TO: T10 Membership
FROM: Paul A. Suhler, Quantum Corporation
DATE: 11 November 2008
SUBJECT: T10/08-409r2, ADT-2: Internet ADT (iADT)

Changes to ADT-2 rev. 5

Figure 5 – ADT communication model

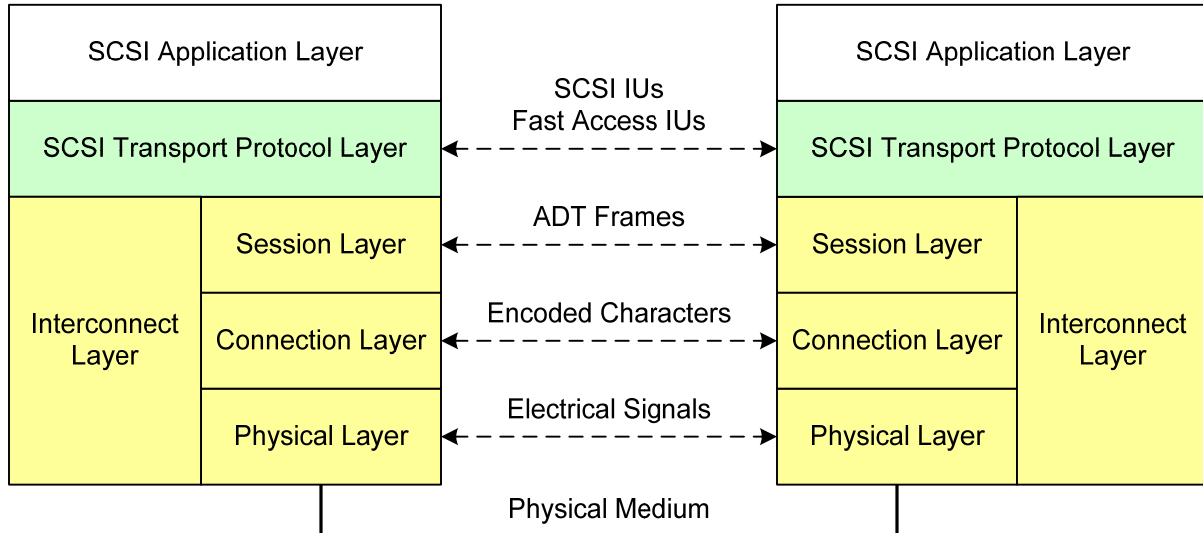
Figure 5 shows the communication between ADT ports at the different layers of the protocol, from the physical layer to the SCSI transport protocol layer.

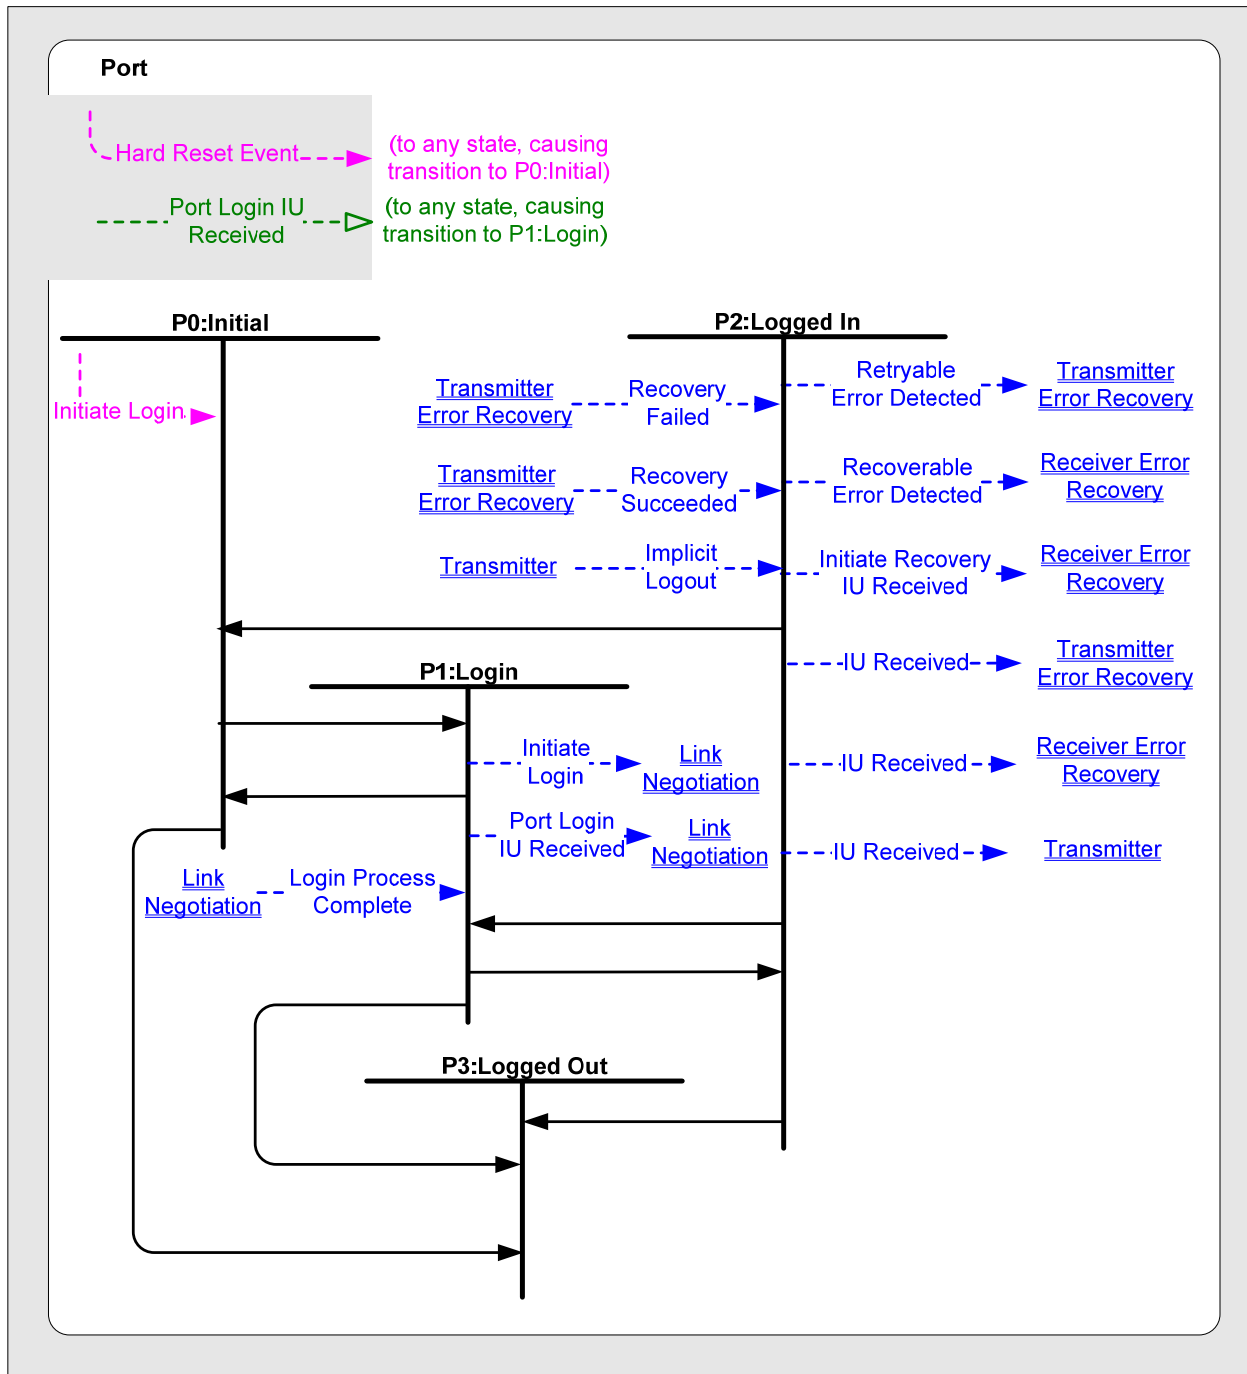
The ADT transport layer contains **five six** state machines to manage **a-connection sessions and connections** between two ADT ports. The state machines are as follows:

- a) port;
- b) link negotiation;
- c) transmitter;
- d) transmitter error recovery; **and**
- e) receiver error recovery; **and**
- f) connection.

The port state machine **is and the connection state machine** are the primary **machine state machines** and **are** always active. The other state machines are only active to manage specific operations (i.e they are sub-state machines of a state in the port state machine). **An ADT port contains one copy of each state machine for each session. The connection state machine only exists in the connection layer of iADT ports. The other state machines exist in the session layer of all ADT ports.**

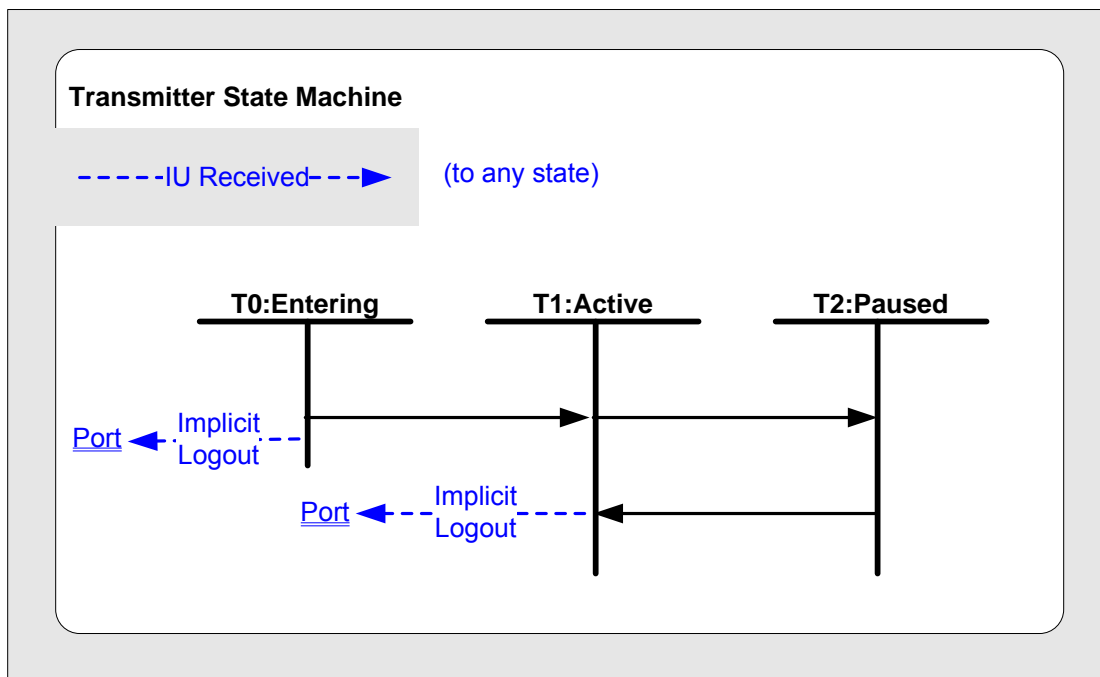
Add the Implicit Logout message to P2:Logged-In state in the Port state machine figure:

A port shall transition to P3:Logged-Out state after it receives an Implicit Logout message.

Figure k – Connection State Machine Diagram

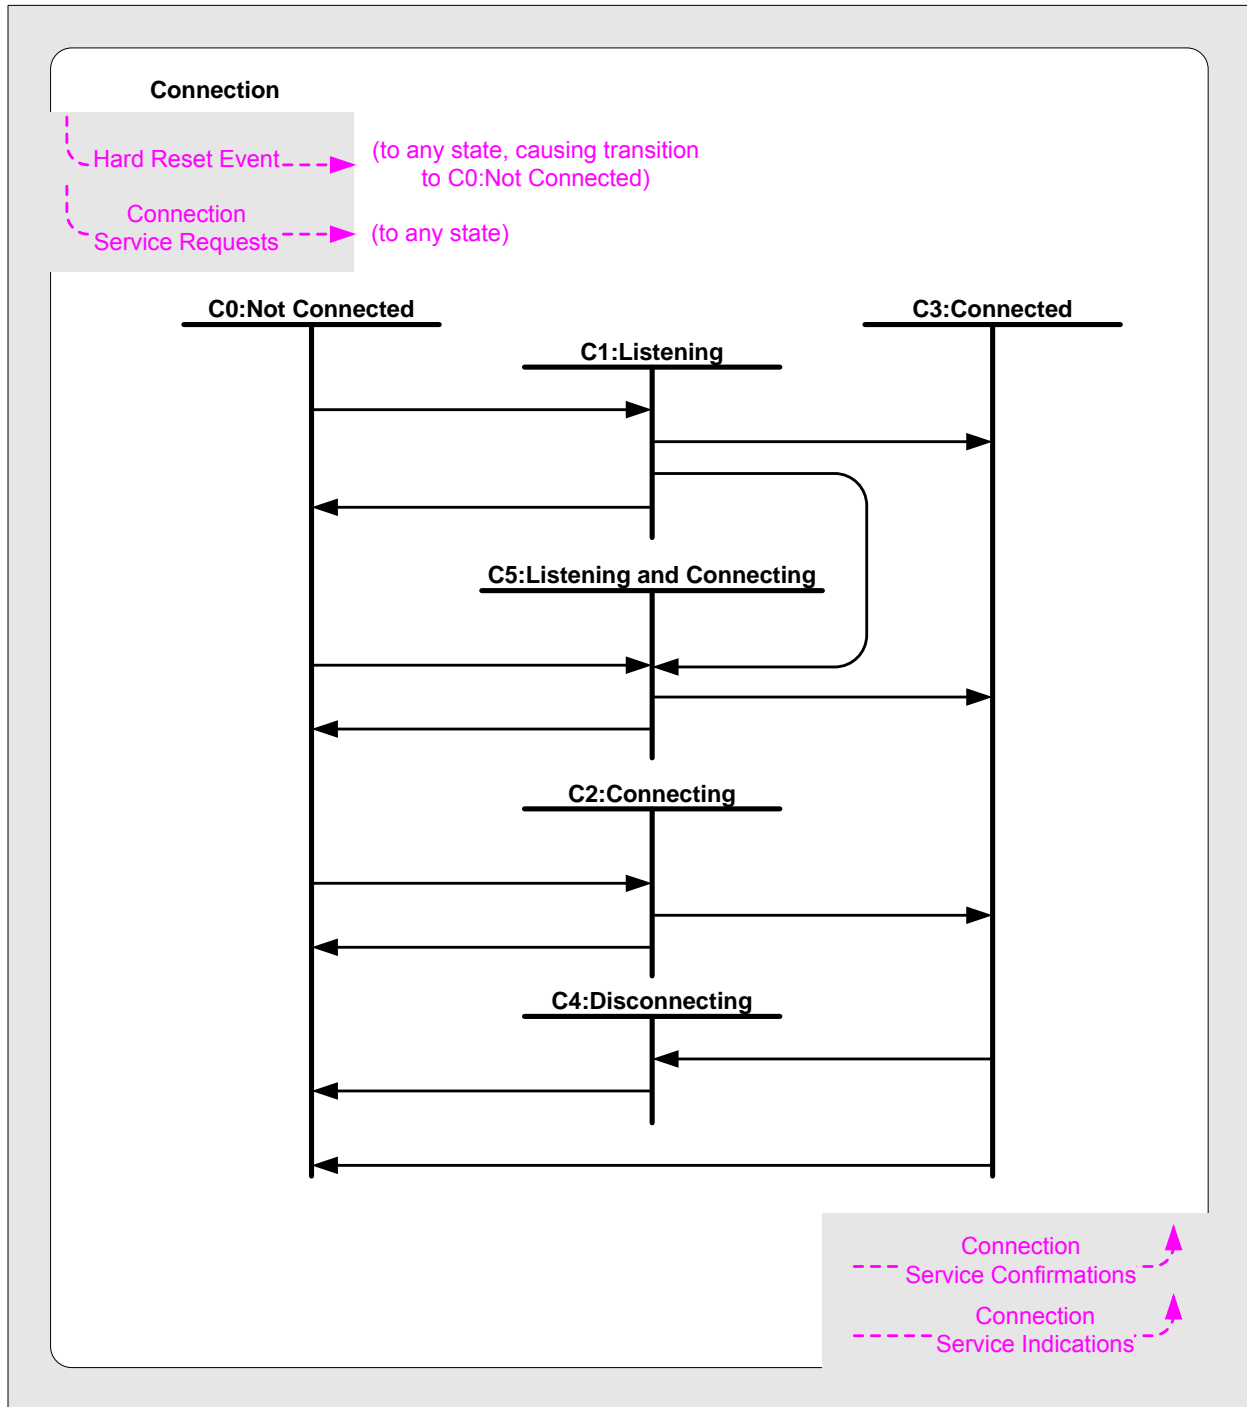
Figure k shows the connection state machine. The following subclauses describe the transitions and the actions taken in each state. For a possible mapping of these actions to the Sockets API functions, see 6.4.6.

Figure 18a – Connection services for establishing a connection between iADT ports

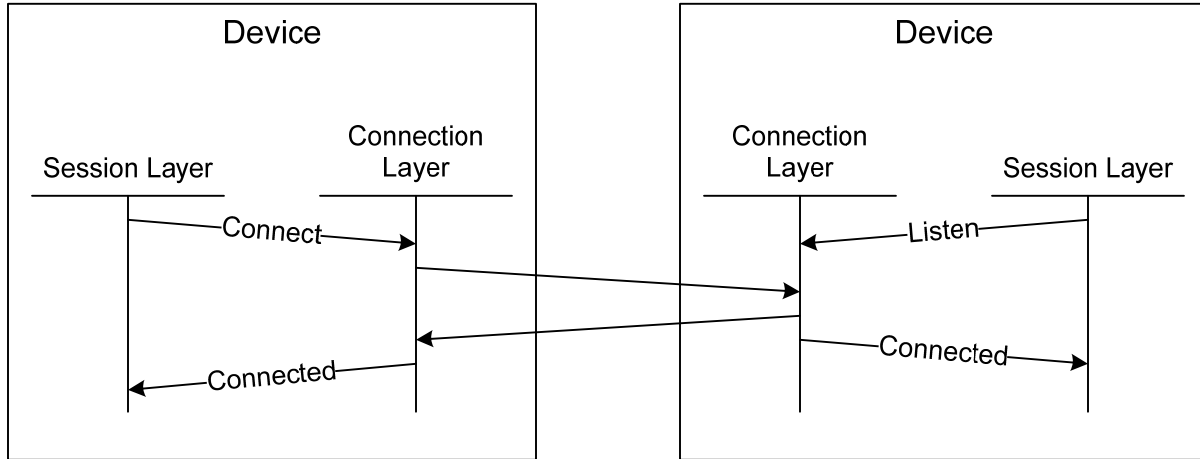
Figure 18a shows an example of the relationships among the connection services used to establish a connection between two iADT ports. The communication between the two devices is defined in RFC 793 and may constitute more than the two communications shown.

The iADT port in a DT device shall invoke the **Listen** service request following a hard reset.

Figure 20a – Connection services for closing a connection between iADT ports

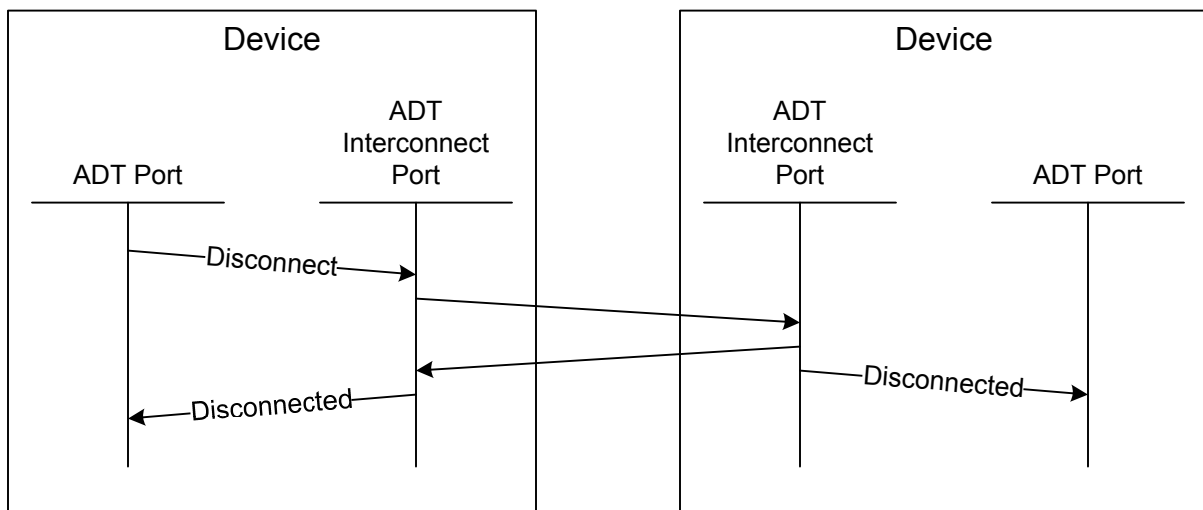
Figure 20a shows the relationships among the connection services used to close a connection between two iADT ports. The communication between the two devices is defined in RFC 793 and may constitute more than the two communications shown.
